Development Review Division

M E M O R A N D U M

SUBJECT: **Parker Central Area McDonald's, Site Plan Amendment**
Review Comments 02

SHEET NO: CD.1

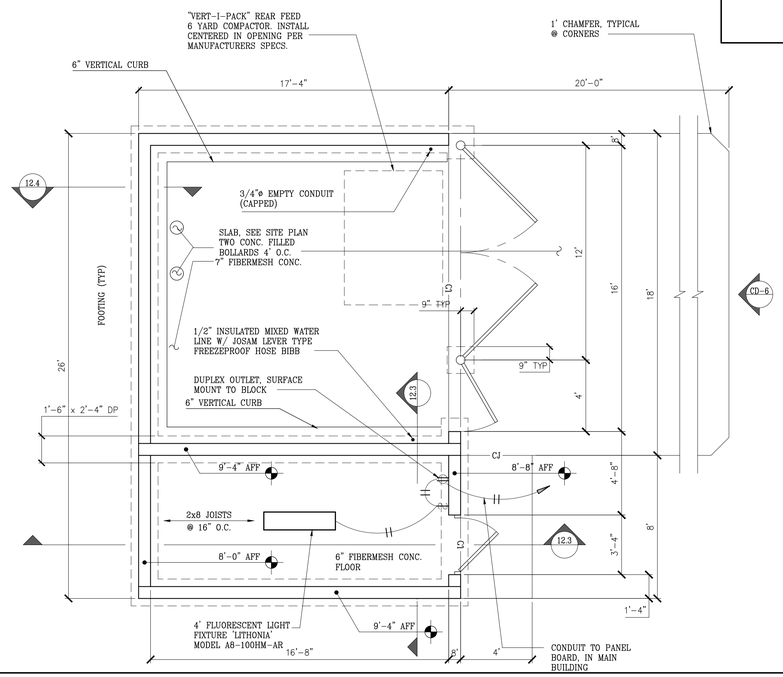
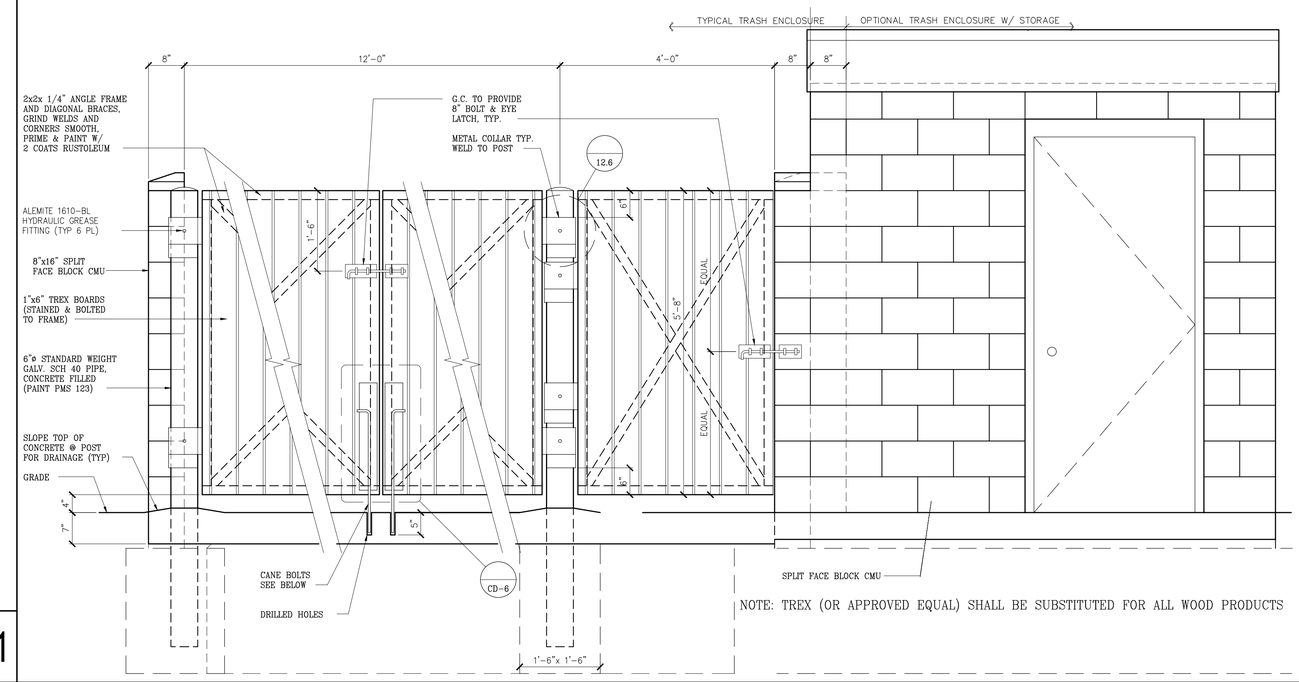
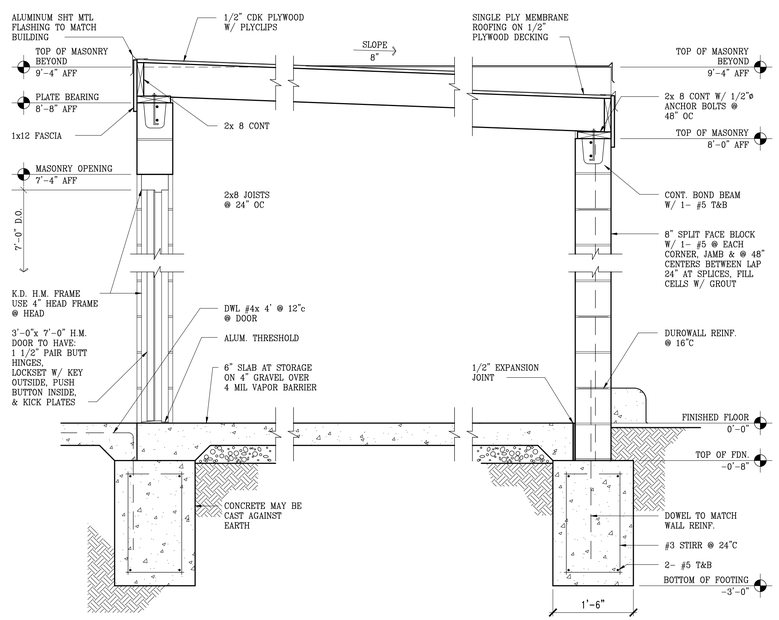
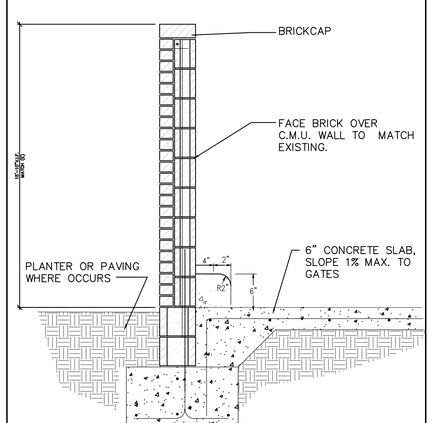
color elevations (all sides) of trash enclosure and storage building needed. both structures must use materials used on the main building.
